Change Order

PROJECT: (name and address)
DOWNTOWN LIGHTING PHASE 2
Project No. 20-2613
CIP No. 51228

CHANGE ORDER INFORMATION:
Change Order Number: C001
Date: January 4, 2021

Cincinnati Crossarm Adder
Muth CO# 001

CINCINNATI Series

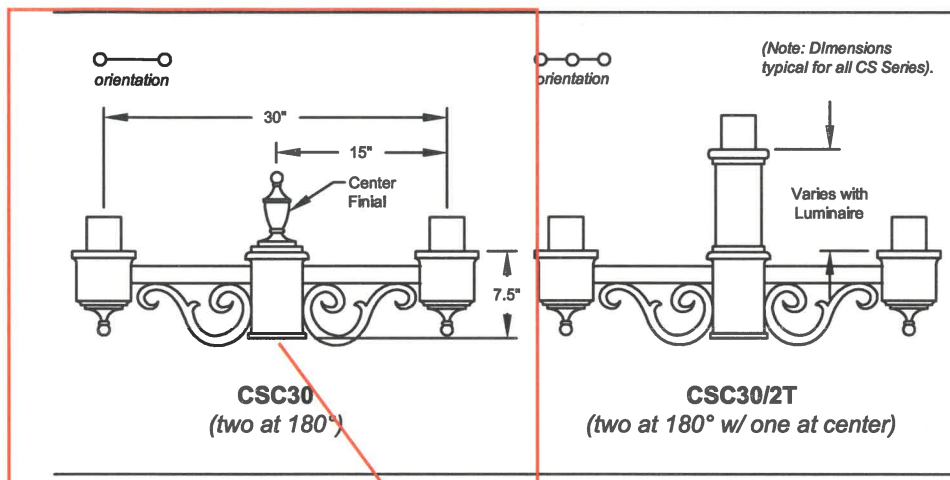
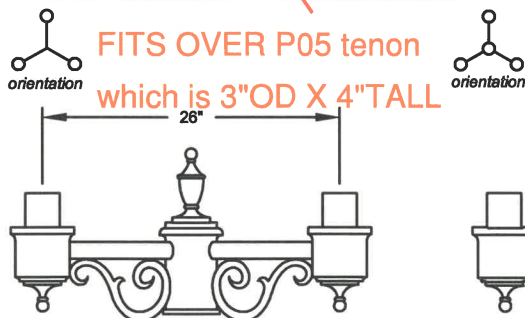
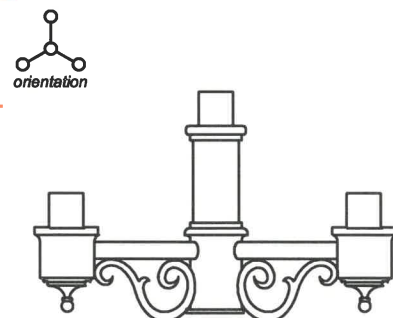
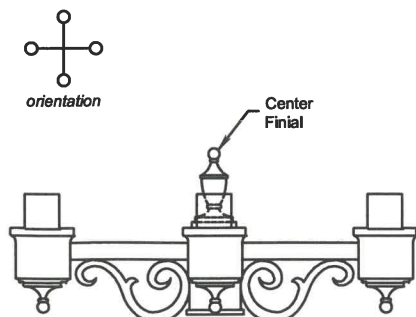
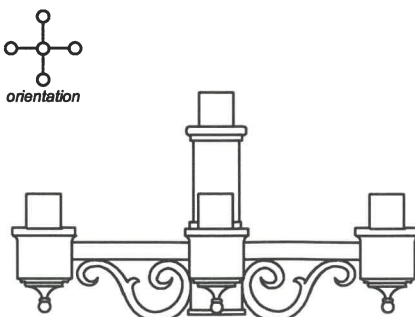
Muth Electric, Inc. would like to propose the following change order pricing for the addition of a Cincinnati Crossarm to (61) luminaire poles. The total cost of the change order request is **\$43,739.00**.

Cincinnati Series Crossarm (CSC): CSC30 (Two at 180), CA, Black
